TECHNICAL INFORMATION BULLETIN

Important Rebuild Information for AL4/DPO Transmissions

Late type hydraulic distributor with 3 notches
Part No. DPO.VB03

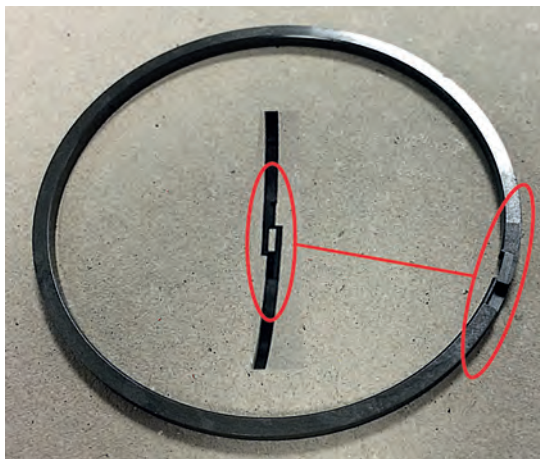
Some units are now being fitted with what is called an NDTH hydraulic distributor, this can be identified by three notches cut out of the separator plate as shown in the illustration below.

It is important that this type of hydraulic distributor, our part number DPO.VB03 is matched to the later style 'E1' Teflon® sealing rings with overlapping joint, our part number DPO.SSR05, see illustration below.

Late type with overlap joint
Part No. DPO.SSR05

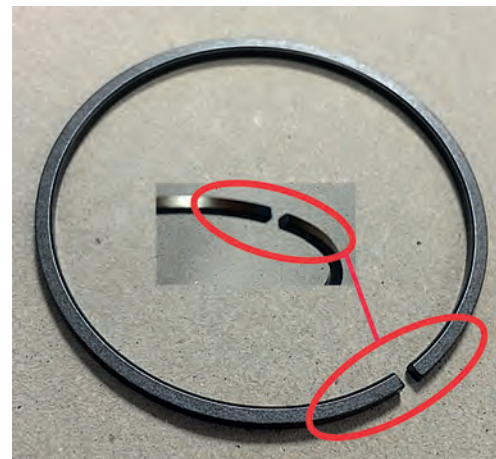
The early non NDTH hydraulic distributor our part number DPO.VB02 must be matched to the early butt jointed sealing rings, our part number DPO.SSR02, see illustration below.

It is very important to make sure when fitting a new hydraulic distributor that the correct type is being fitted, or if rebuilding the unit that the correct sealing ring/hydraulic distributor combination is used.

Please be aware that mixing incorrect sealing ring and hydraulic distributor combinations will without exception result in premature transmission failure.
